UNITED STATES PATENT AND TRADEMARK OFFICE

Office Action Summary	Application No. 10/830,207	Applicant(s) TJAKRA, HORACE	
	Examiner Jessie Fonseca	Art Unit 3637

DETAILED ACTION

Figure 8: Wirkus et al. (US 5,845,443)

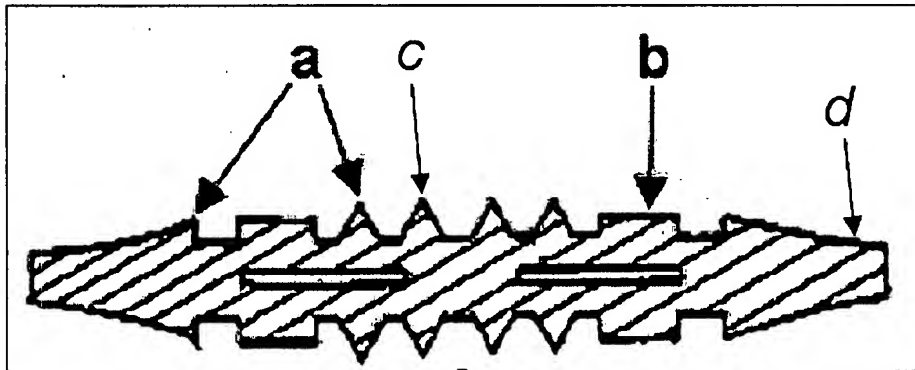
Regarding claim 1: Wirkus discloses a spacer (25) (fig. 8) comprising:

Plurality of projections (a, b) that extend outward from the profile of the spacer (25) (fig. 8 and col. 3, lines 31-34);

Regarding claim 5: Wirkus, in view of Alcazar, further discloses a plurality of projections that are ridges (b) (fig. 8).

Regarding claim 7: Wirkus, in view of Alcazar, further discloses a plurality of projections that are ridges (b) and pointed projections (a) (fig. 8).

Regarding claim 9: Wirkus, in view of Alcazar, further discloses an elongated spacer comprising a plurality of projections (a, b) shaped as ridges (b) or pointed (a) projections that extend outward from the profile of the spacer (fig. 8 and col. 3, lines 31-34). Wirkus, in view of Alcazar, further discloses the sections having varying walls thicknesses from one another, where one of the sections has a portion (c) that is thicker than the portion (d) of the other section (fig. 8).

Wirkus does not show the elongated spacer having a teardrop shaped in cross section. However, Alcazar shows an elongated spacer having a cross-section profile in the shape of opposing teardrop sections (fig. 1). The teardrop section consists of one end having a bulbous shape and tapering to a point on the other end. Therefore, it would have been obvious to one of ordinary skill in the art at the time of the invention to
